**TOWN LAKE OF PARK
PLANNING & ZONING BOARD
STAFF REPORT
MEETING DATE: April 3, 2023**

APPLICATION: Oceana Coffee Roasters Site Plan Amendment

RE: Project No.: 5589
Project Name: Oceana Coffee Site Plan Amendment #1

REVISIONS:	
1	11/15/21 2nd. ROUND OF COMMENTS
2	11/29/21 3rd. ROUND OF COMMENTS
3	12/07/21 4th. ROUND OF COMMENTS
4	03/14/23 SITE PLAN AMENDMENT
5	03/21/23 COMMENTS
DATE 11/02/2021	
DRAWN : REVIEW	
SCALE SITE PLAN	
DRAWING TITLE: EXTERIOR ELEVATIONS	
SHEET No: A-201

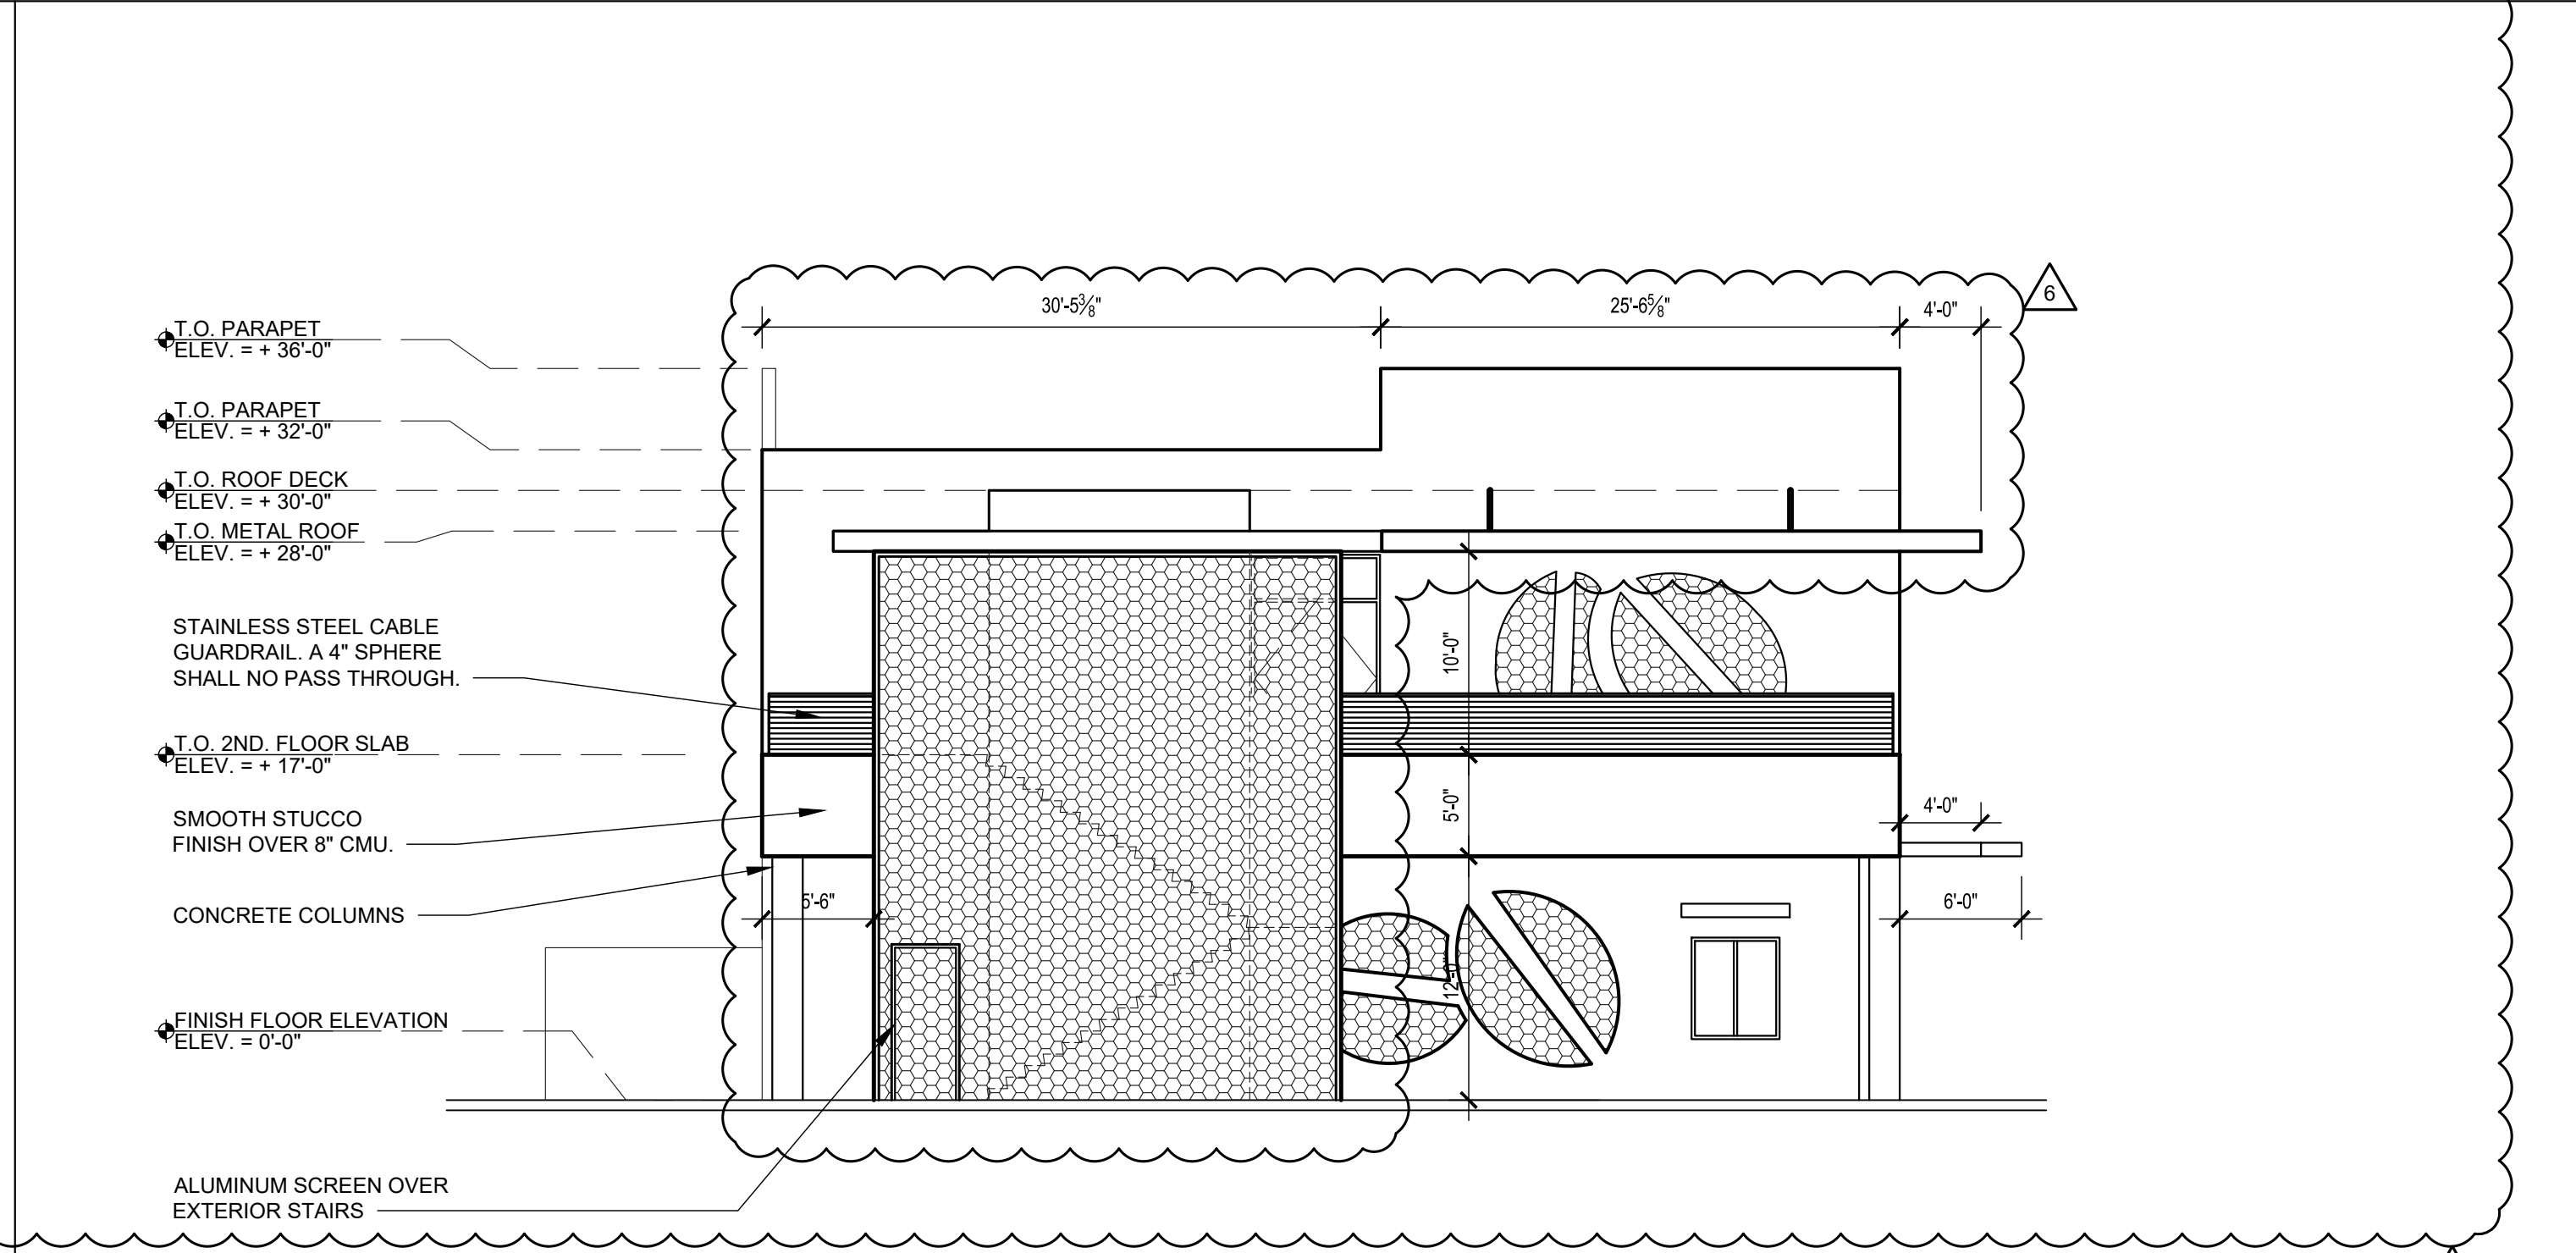
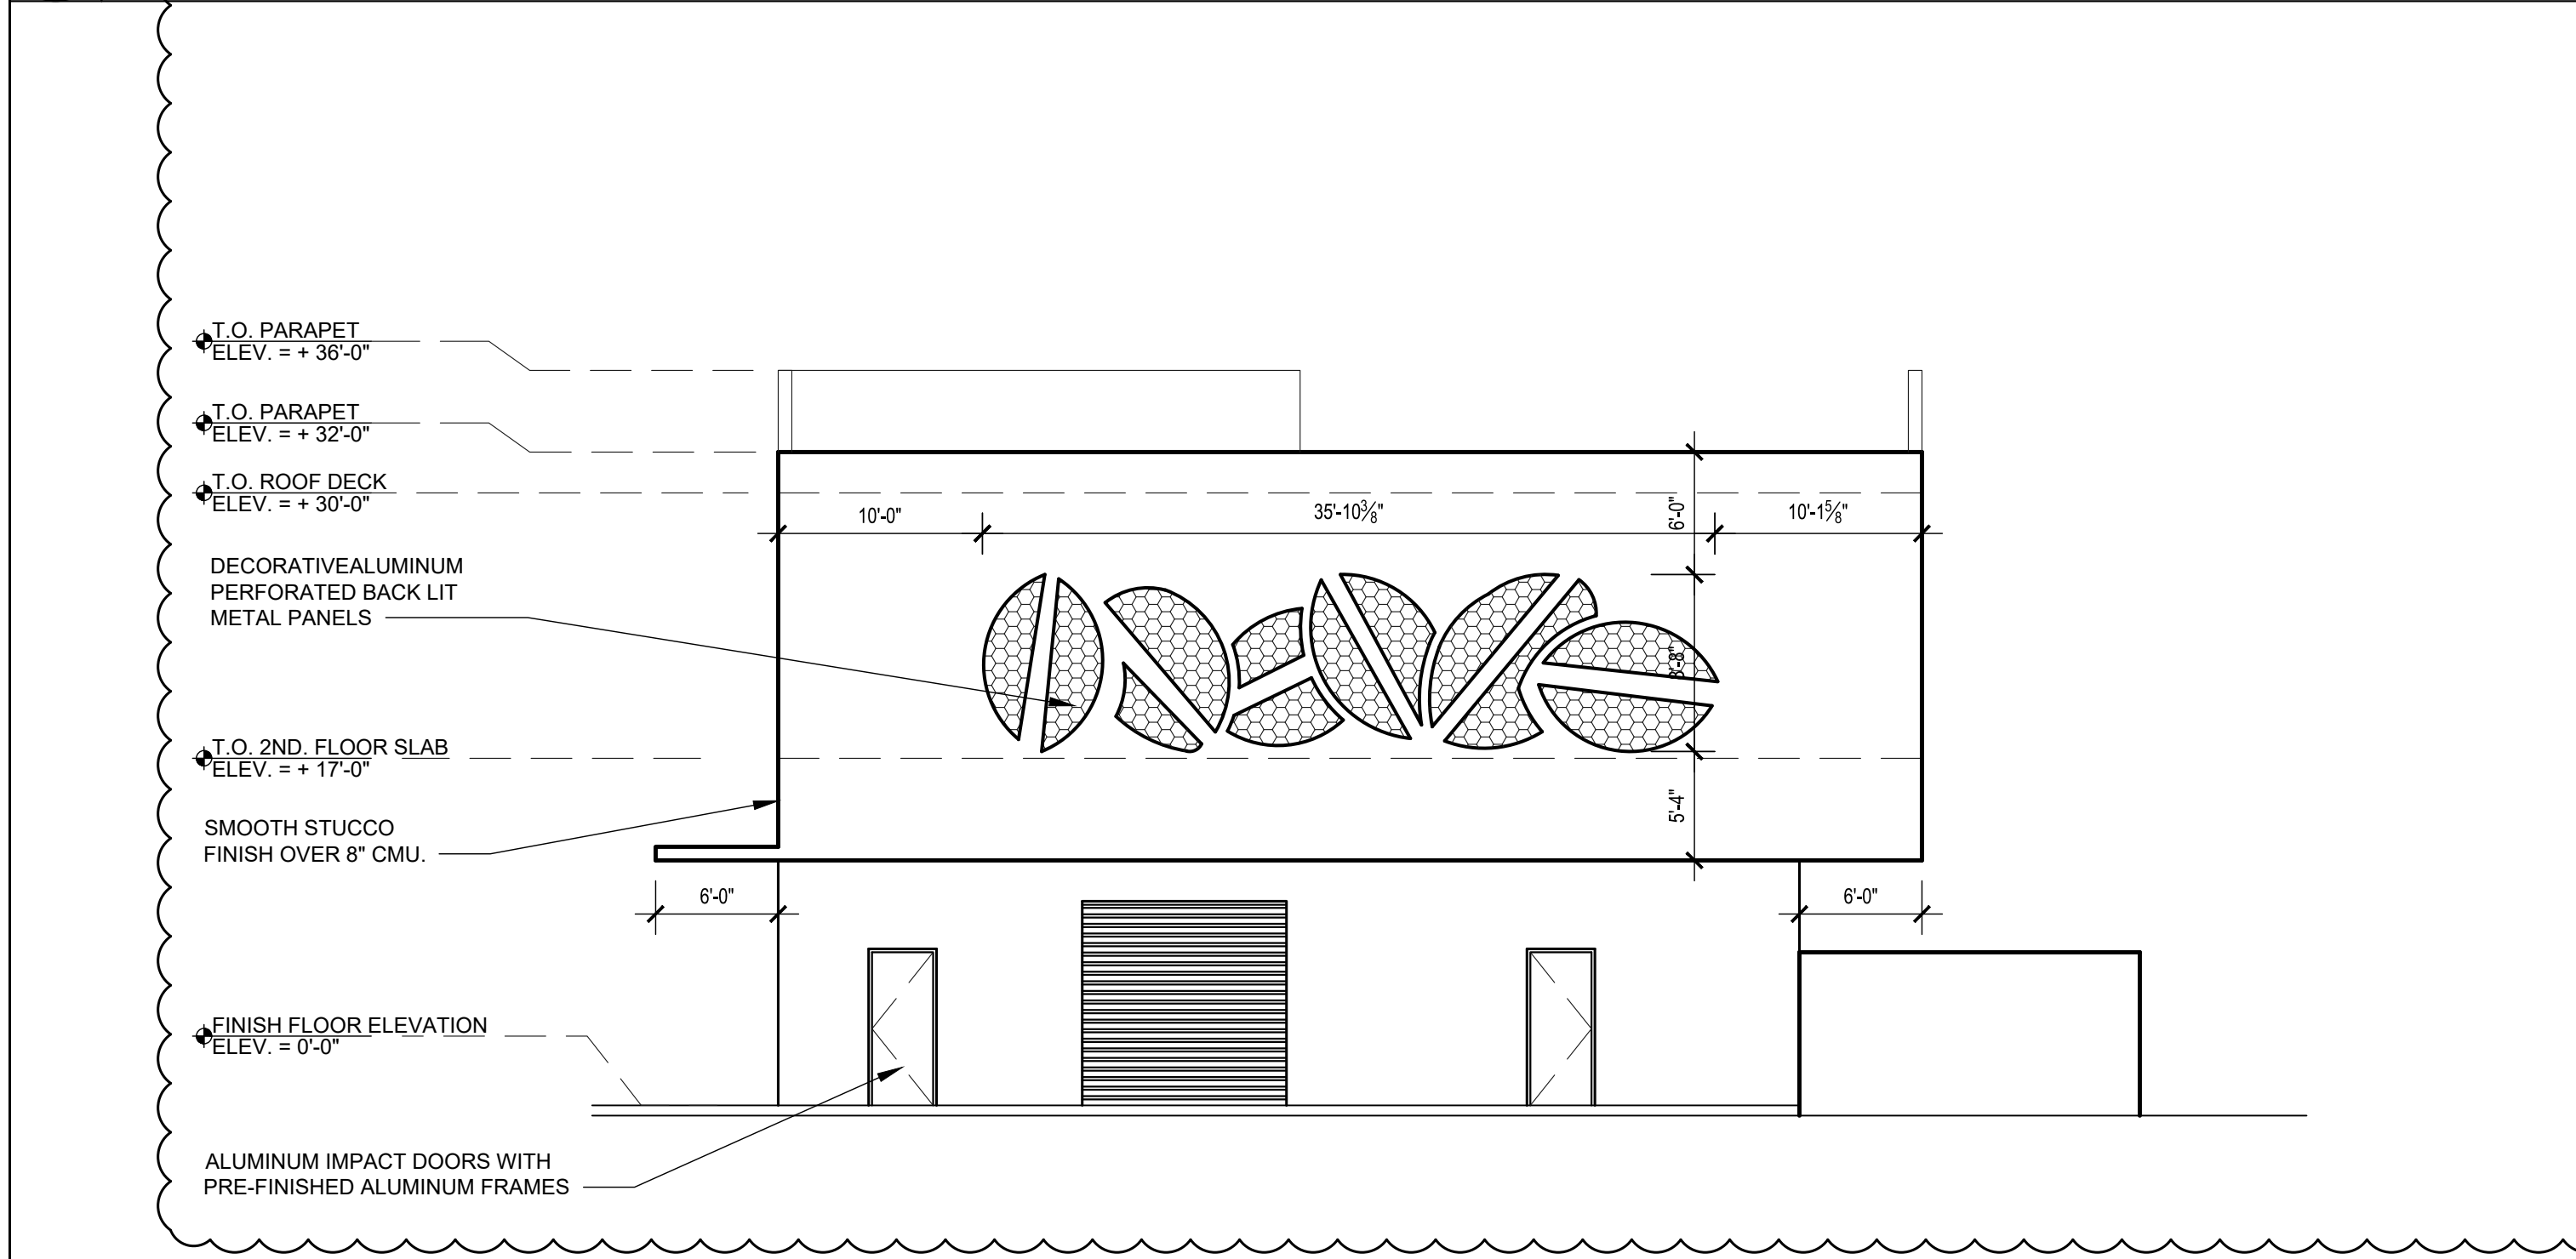
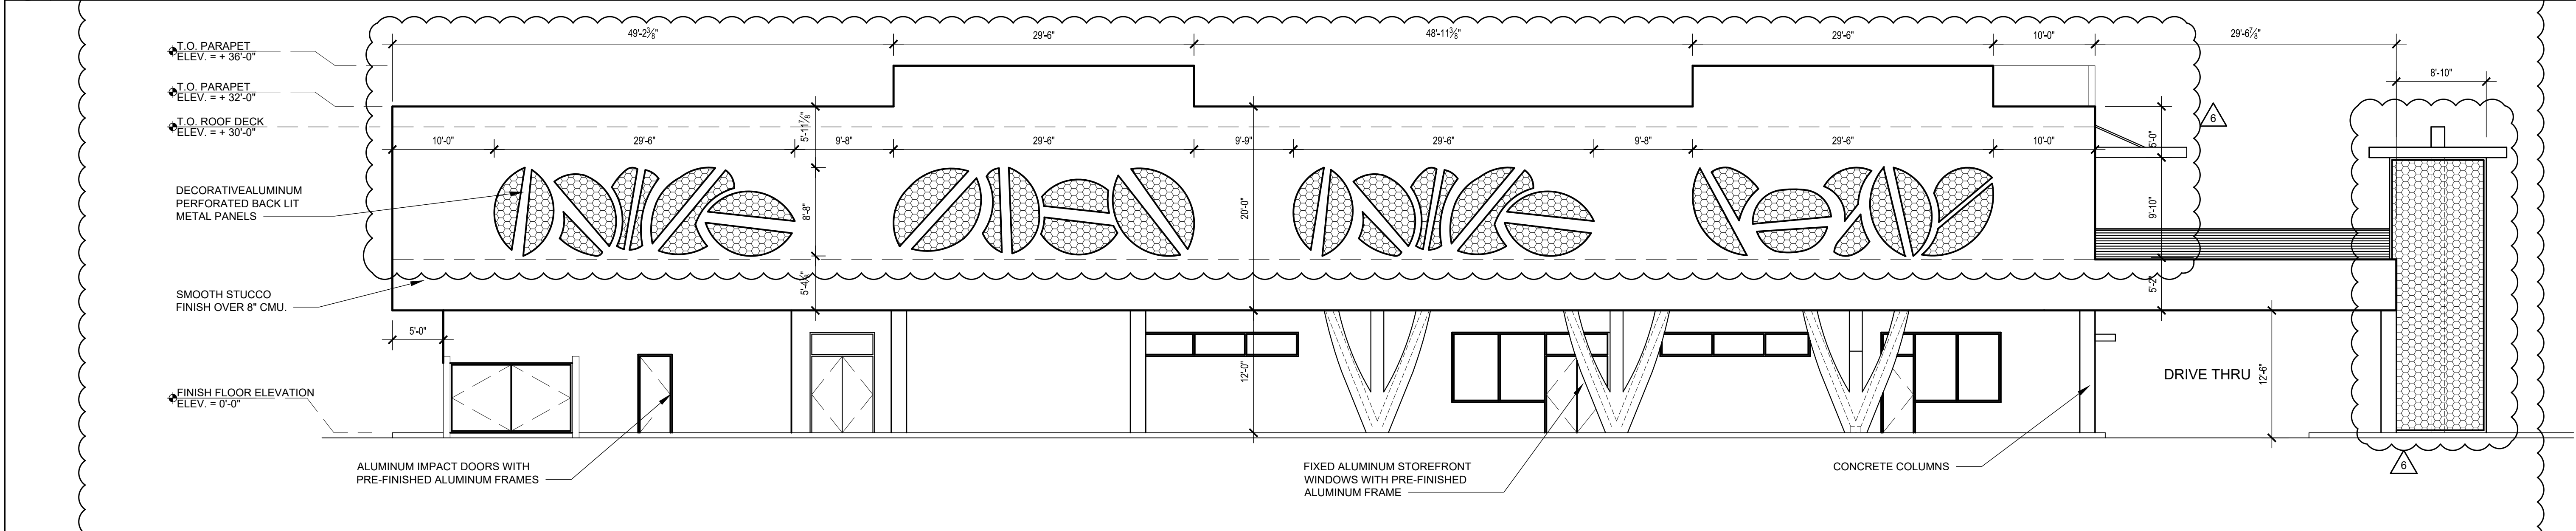
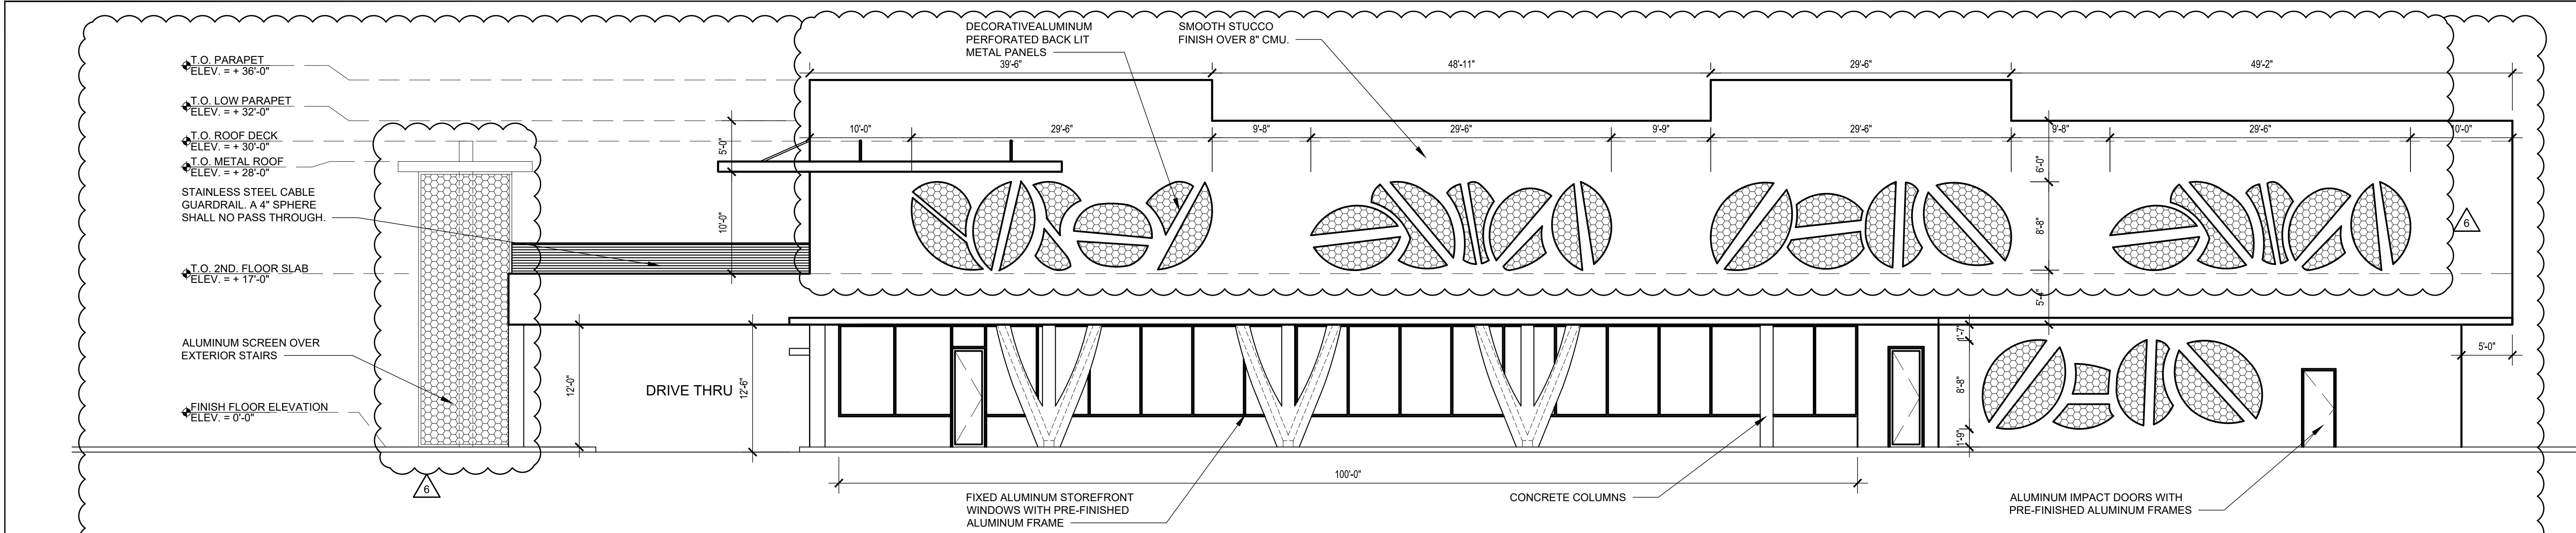
8. Renderings need to be consistent with all plans. For example, the northern stairway as shown in the rendering is not oriented in the same direction as the landscape plan depicts. In addition, the dimensioned elevations (A-201 and A-202) illustrates the screen around the stairway different than the rendering illustrates it. Please make these and other features consistent across all plans sets so that Staff understands the true proposal. Another example are the two doors on the second level depicted in the rendering. The dimensioned elevations (A-201 and A-202) depict one double-door configuration, along with the overhead canopy positioned differently. The metal panel coffee beans are also different in quantity and positioning on the renderings versus the dimensioned elevations. Another example is the first-floor drive-thru area that is

rendered with metal panel coffee beans on the wall and a canopy over the drive-thru window whereas the dimensioned elevations do not illustrate these features. The renderings also do not adequately illustrate the northern outdoor landscape/hardscape area as they are detailed on the site plan sheets.

On the west elevation on the north side, the canopy feature is not consistent between the black and white (A-201) and color elevation (A-202) sheets (just one example); please revise and ensure A-202 matched A-201.

RESPONSE: Rendering has been revised to reflect all the stipulated modifications as delineated in the site plan comments.

RESPONSE#2: Please refer to revised renderings & A-202
